Response to Reviewer #1's Comments

Response to Reviewer #2 (Polina Lemenkova)

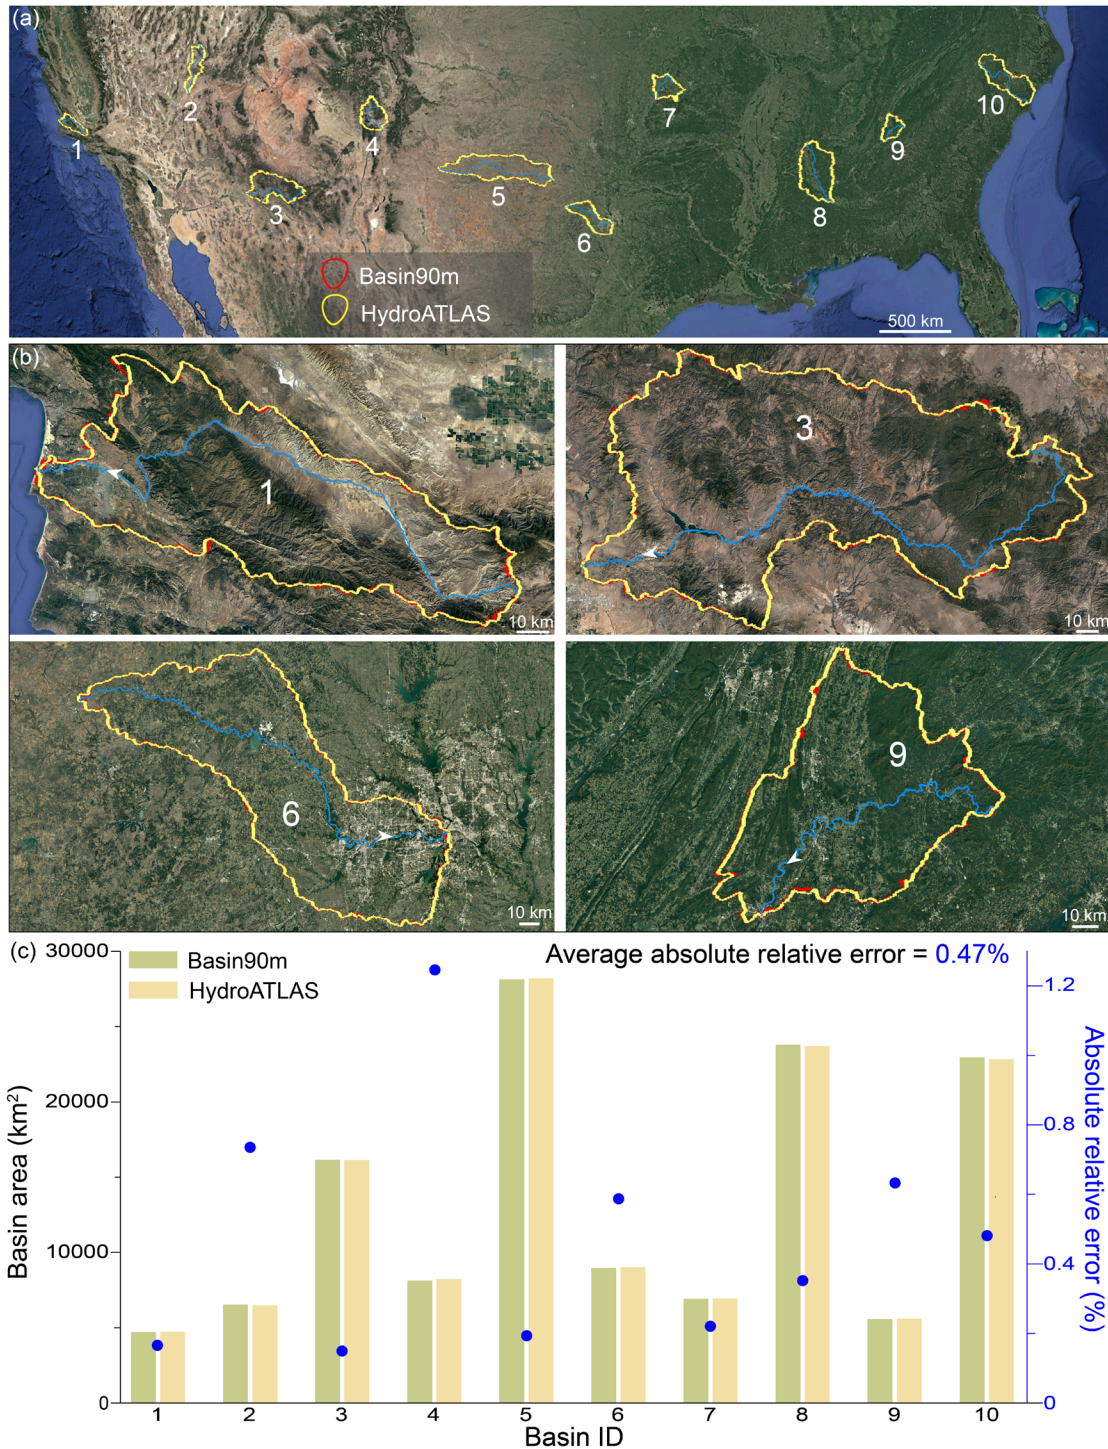
4. The validation of the dataset is far from enough only doing it in a specific basin. More validations are needed, for example comparing with measured basin area (there are many measured basin area in the US as far as I know), or a global comparison of basin area from Basin90 and HydroSheds.

Therefore, we selected 10 basins across the USA for comparison (please see Fig. 9 below). To capture diverse terrain, climate, tectonics, and vegetation conditions as much as possible, these 10 basins are evenly distributed along the east-west direction of the USA. The average absolute relative error of basin areas from these 10 basins in the two databases is less than 0.5%, indicating consistency between the two databases in delineating basin boundaries.

Based on the above results, we added a **new figure (Fig. 9)** and a **new section (Section 4.3 Accuracy of basin area)**. On this basis, we also made modifications to other relevant sections of the manuscript (such as the Conclusion section).

Drainage area is an important metric to evaluate the accuracy of drainage basin delineation. We compared drainage areas in Basin90m with those in HydroATLAS (Linke et al., 2019). We selected ten basins across the USA for comparison (Fig. 9a). These drainage basins are evenly distributed in the east-west direction across the North American continent, thus spanning diverse geological regimes, terrains, climates, and vegetation environments. Basins #1-5 are located in the west with arid climate, steep topography, and relatively active tectonics. Basins #6-10 are located in the east with low topographic relief but more precipitation and vegetation.

do not always coincide (Fig. 9b). But the two databases are consistent without substantial discrepancies (Fig. 9c). We quantified their difference using absolute relative error. The absolute relative error is the absolute value of the area difference between Basin90m and HydroATLAS as a ratio to HydroATLAS. Smaller values indicate higher agreement between the two datasets. Except for a 1.2% absolute relative error for basin #4, the values for the other nine basins are below 0.8%. The average absolute relative error for the ten basins is 0.47% (Fig. 9c). This slight discrepancy is acceptable given the nearly five-fold difference in DEM resolution and variations in algorithms for basin delineation.
